CAPRICORN MUNICIPAL DEVELOPMENT GUIDELINES

2022 MEETING 10 MINUTES

Date and Time: 17 November 2022 10:00 am

D05.18. PIPE MATERIAL

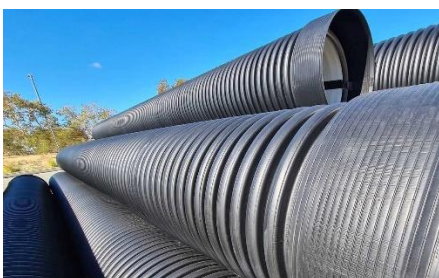
- C221 Section C221.04 mentions FRC and RCP pipes but not Plastic.
- Current Section D05.18 reads as follows.

- It is noted that Hydra Storm supplies pipe as follows:
 - Manufactured in accordance to AS – NZS 5065
 - Available from Diameter Nominal (DN) 225mm to 600mm
 - Manufactured from recycled HDPE

- C221 will need to be updated at the same time as D5.
- Richard mentioned that he is meeting with a representative from Iplex next week where he will get additional information and specifications.

- Richard has met with the sales Rep but proposed changes to D5 and C221 are still being considered. It is recommended that Polypropylene pipes with classification SN8 are approved up to a diameter of 600mm.
- The technical guide for Blackmax (Iplex) is included as ~~Attachment N~~.
